AMENDMENTS TO THE DRAWINGS

Attached hereto are five (5) sheet(s) of corrected formal drawings that comply with the provisions of 37 C.F.R. § 1.84. The corrected formal drawings incorporate the following drawing changes:

FIG. 4

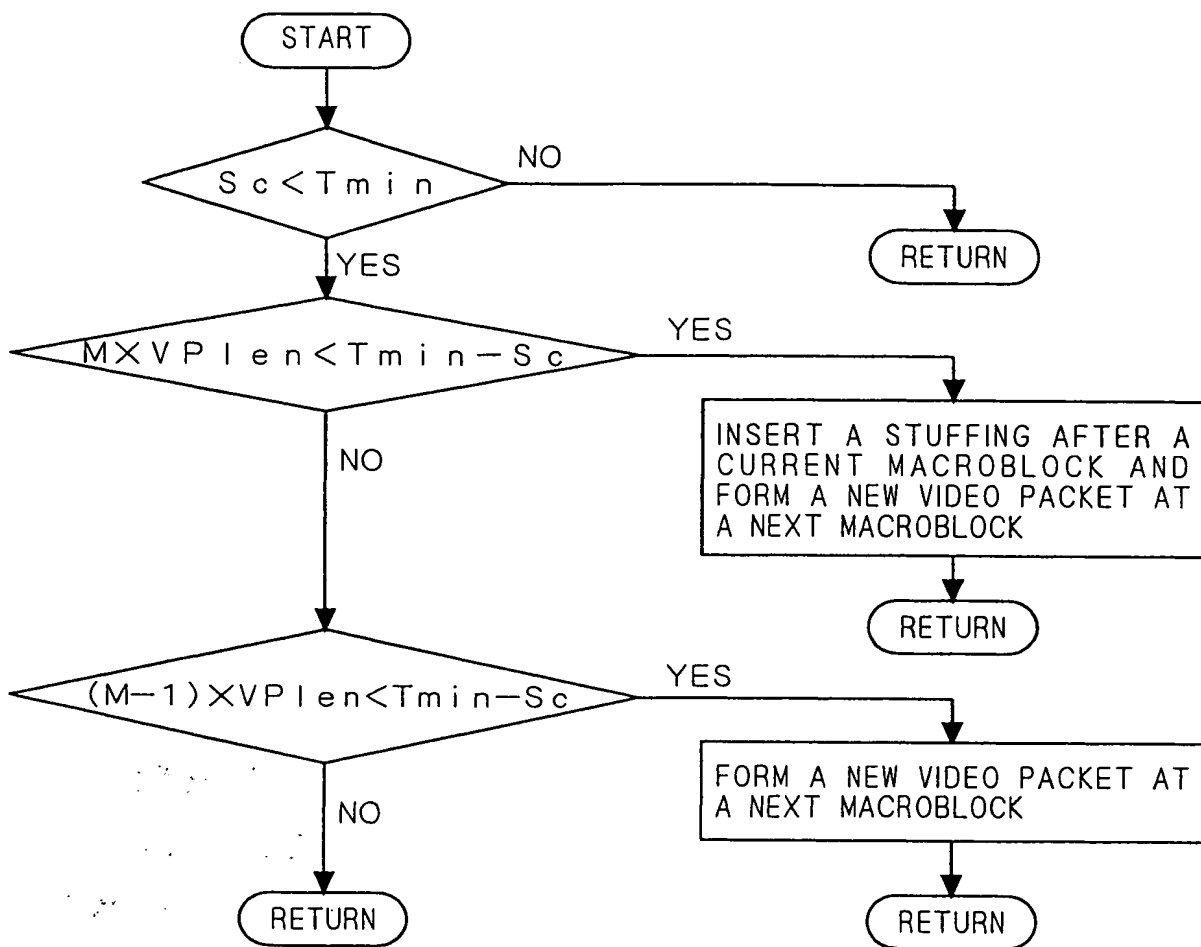
Fig. 4 – Please correct “MACROBROCK” to --MACROBLOCK--.

FIG. 6
CONVENTIONAL ART

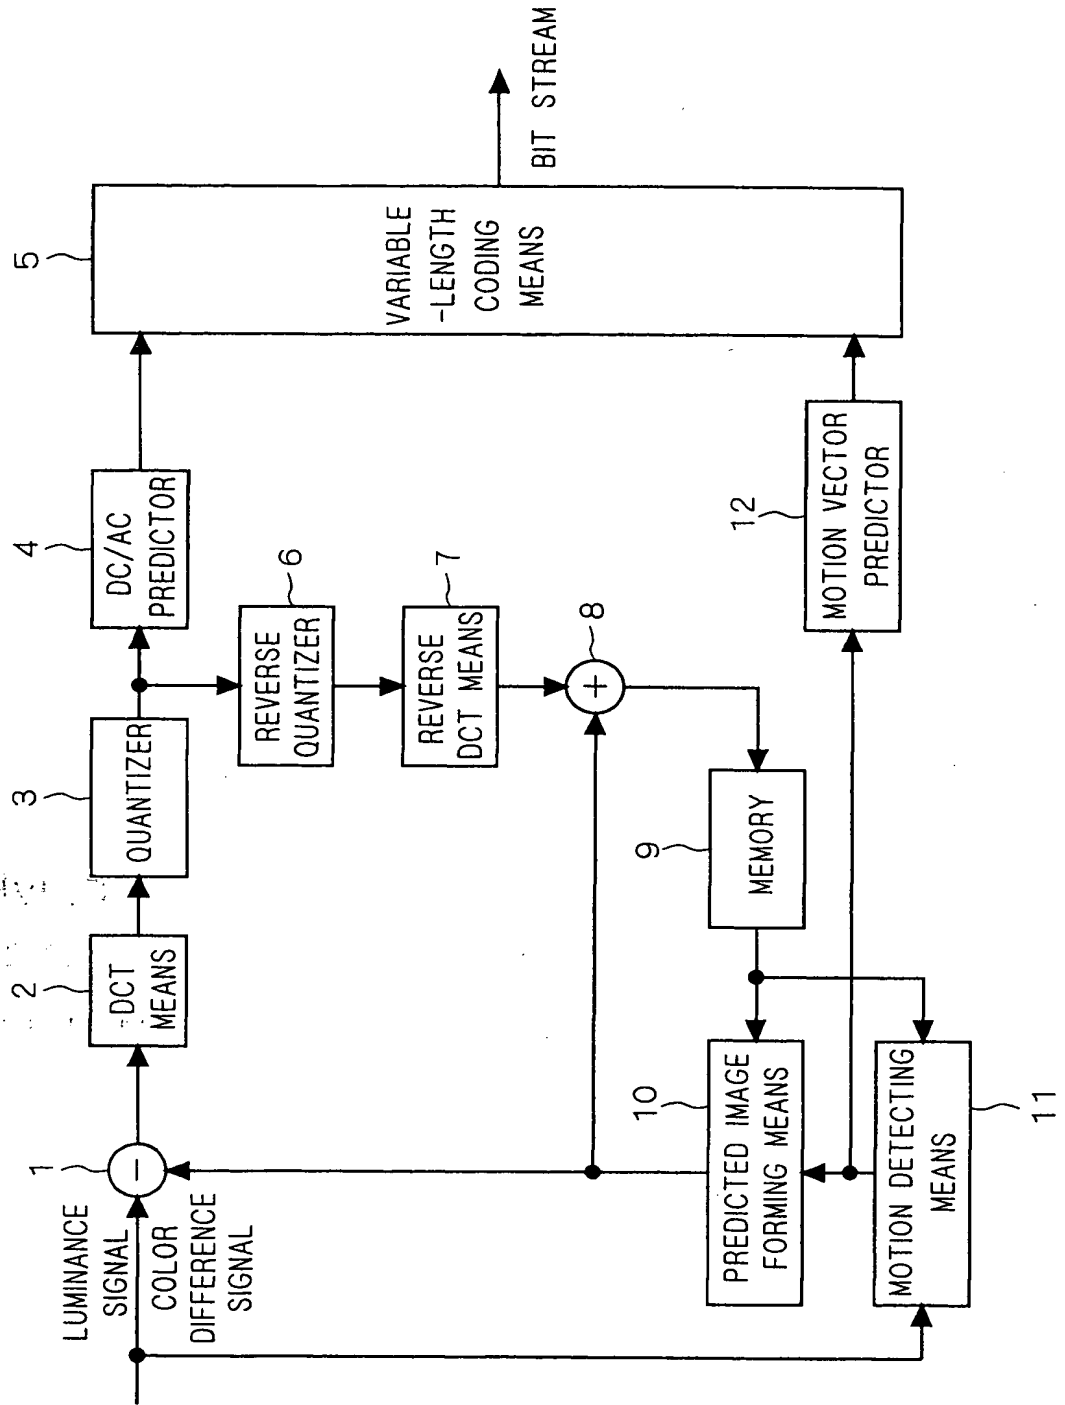
Figs. 6, 7, 8A and 9, please label as “CONVENTIONAL ART”.
